**Christchurch City Council**  
**Safe Speed Neighbourhoods**  
**AGENDA**

3. Safe Speed Neighbourhoods ..... 7

4. Safe Speed Neighbourhoods - Volume of Submissions ..... 27

## 4. Safe Speed Neighbourhoods - Volume of Submissions

Somerfield Road - yellow line indicates possible extension to integrate driver / user experience

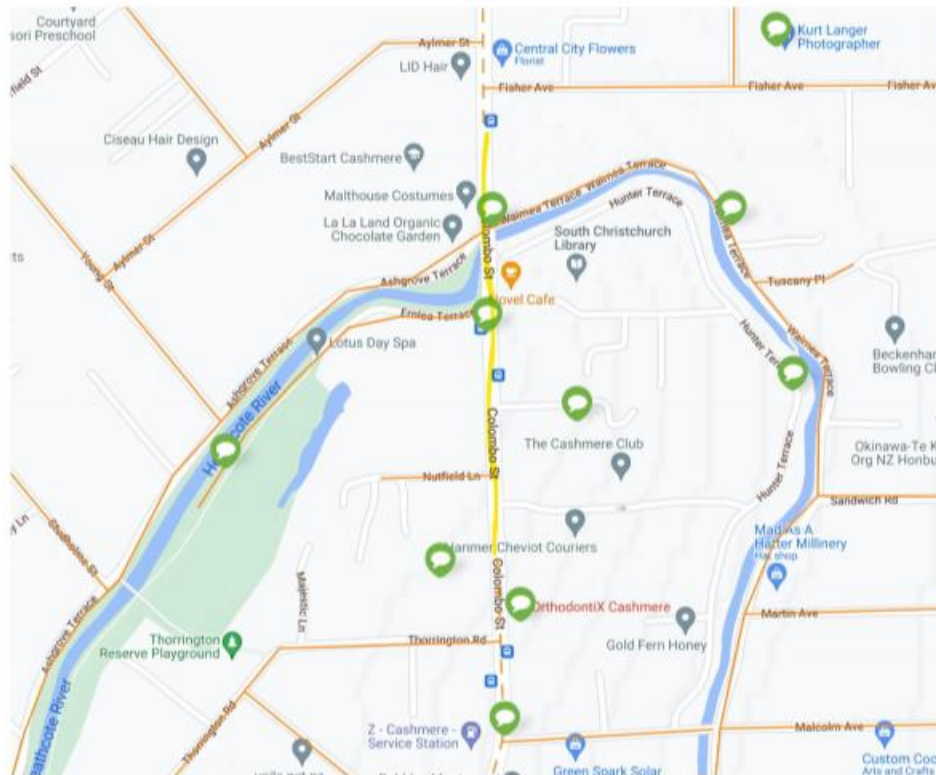
As below there are a number of areas from this quick snapshot where the 30km/hour (school times) stops short of a natural road crossing or interconnected 30km/hour road. This may cause driver confusion when driving 30 at school times, then there is 100 metres of 50 then back into a 30km zoned street again.

One recommendation is for a quick integration review and 'join up the dots' to the nearest intersecting 30km road.

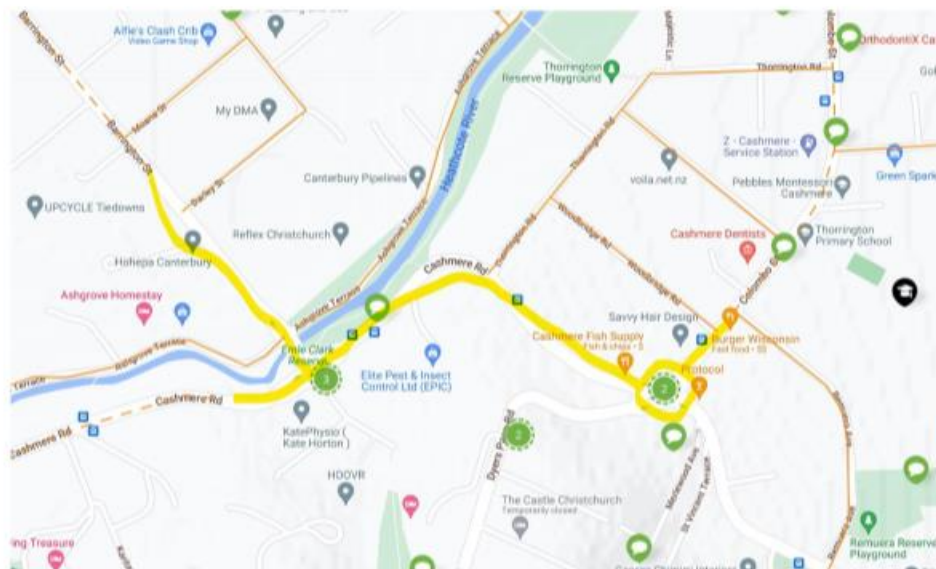
Colombo Street between Fisher (many high school students turning right into Ashgrove Tce to get to Cashmere High), and down past South Library to connect to the next strip of dotted lines.

Barrington / Cashmere / Colombo / Dyers Pass roundabout - connect the dots here as there is only one side of Cashmere Road with a footpath (north side) which limits capacity for walkers, scooters, cyclists etc. Also drivers from Thorrington Road speed up to turn right into Cashmere Road when they are on a left turn only (very common); and lastly, I understood the Dyers roundabout improvements included reduced speeds as per the bullet point from the page link below, so perhaps this map needs updating in light of that?

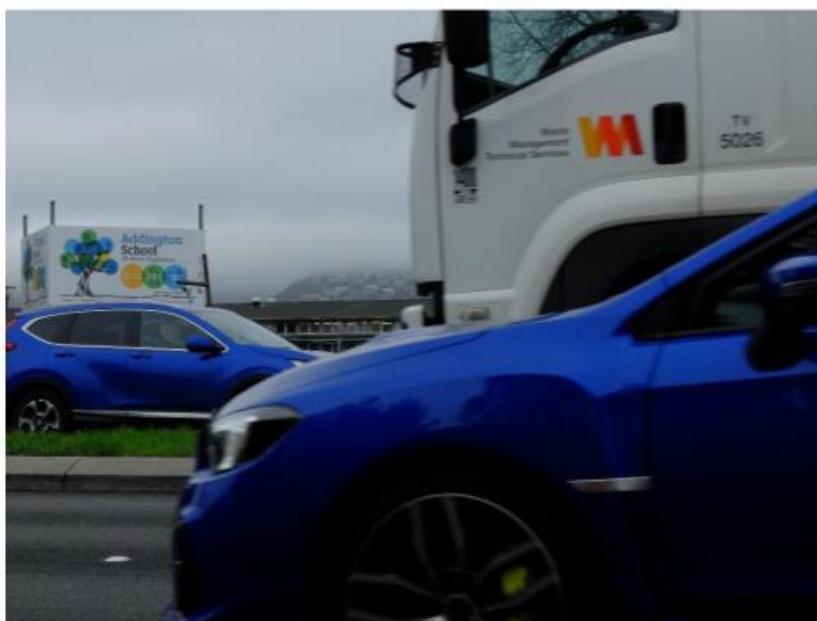
*Speeding rat-runners, such as this one turning into Macaulay Street, are a curse on our neighbourhood and compromise the safety of people walking, scootering or biking to and from our school*

Figure 1: Safe Speed Neighbourhoods Map of Cashmere High School – extension to the speed limit reduction (highlighted in red)

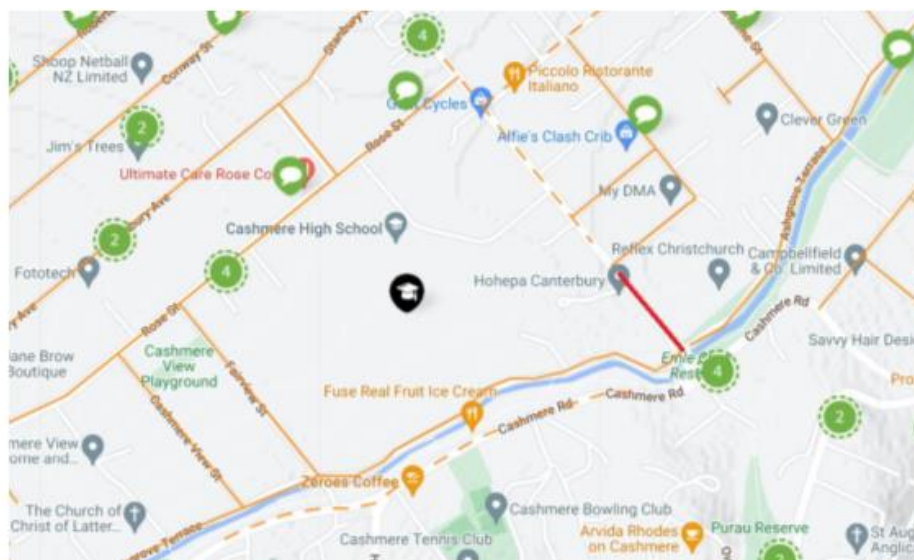
The Ministry requests that the Cashmere High School 30 km/h speed zone is extended to the Barrington Street/Cashmere Road roundabout as outlined below in Figure 1:

The Safe Speed Neighbourhoods Map of Cashmere High School has an anomaly near the Barrington Street/Centaurus Road roundabout where the speed limit remains at 50km/h. This area is frequented by kura tamariki and whanau and should be included within the 30km/h area, particularly given it forms part of the primary transport route for public transport, pedestrians, cyclists and private vehicular transport.

### Proposed changes for the Crossing

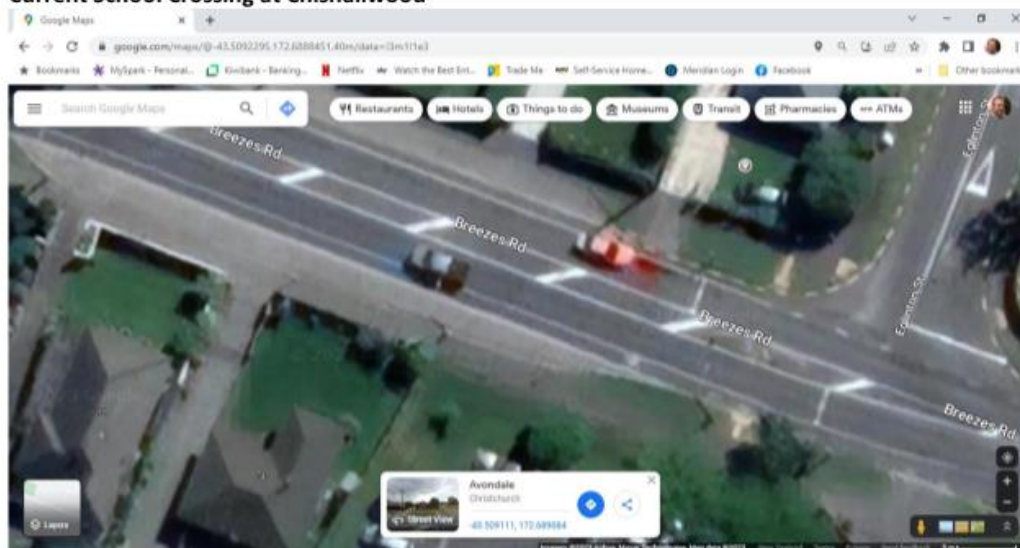
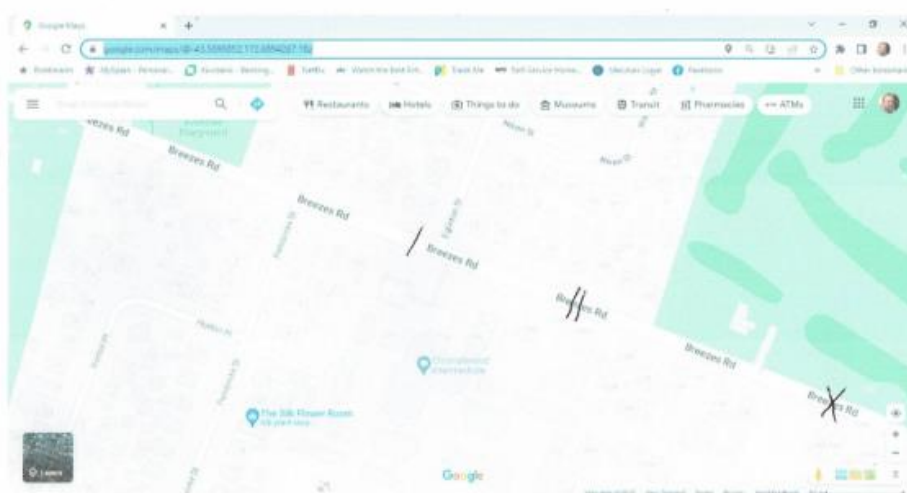
**A Pedestrian Crossing on Breezes Rd near the old Avondale Primary School needs moving or getting rid of.**

We as a community group support Chisnallwood Intermediate in its endeavours to keep its students safe while on their way to and from school, however the school is unable to keep the pedestrian crossing, located outside the old entrance to the now closed Avondale Primary School, manned as it is too far away from the intermediate, once when Avondale Primary School was open (before 2016) it worked well but for the last 6 years it has been very problematic!

This is the area where in December a student almost got run over one afternoon at the end of a school day. Students seem to get to this pedestrian crossing and run over between cars, often in the morning if you're travelling away from the intermediate up to the Wainoni intersection, the sun between the trees can blind you to seeing a kid coming towards the old crossing who may think they can get across before you get to the crossing.

Key  
 / = Current Crossing - needs to be Highlighted with White Lines  
 == Proposed New Crossing by 106 Breezes Road  
 X = Getting Rid of the old Crossing at End of Our School
